TRANS/WP.29/GRSP/35  
14 July 2004

REPORT OF THE WORKING PARTY ON PASSIVE SAFETY (GRSP)  
ON ITS THIRTY-FIFTH SESSION

(3-7 May 2004)

PROPOSAL FOR DRAFT CORRIGENDUM 1 TO THE 06 SERIES OF AMENDMENTS TO  
REGULATION No. 14  
(Safety-belt anchorages)  
(see para. 16 of this report)

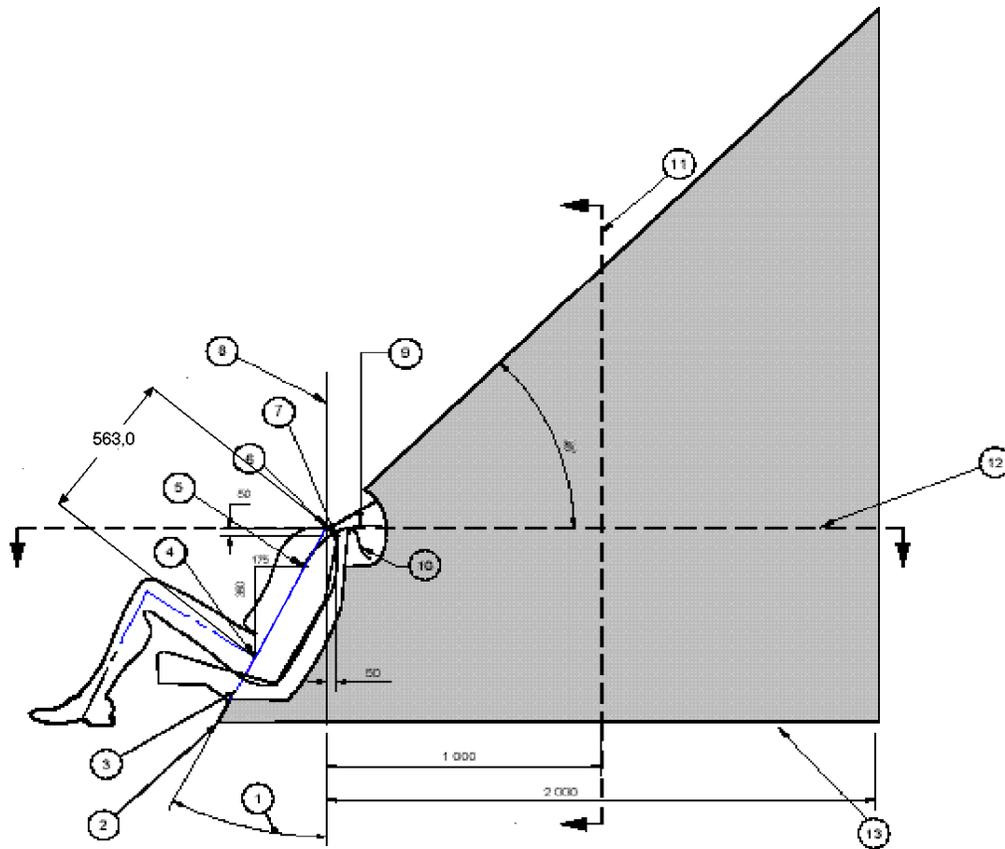
Insert a new dimensioning of 563.0 mm in figure 6 between R point and H point as indicated below:
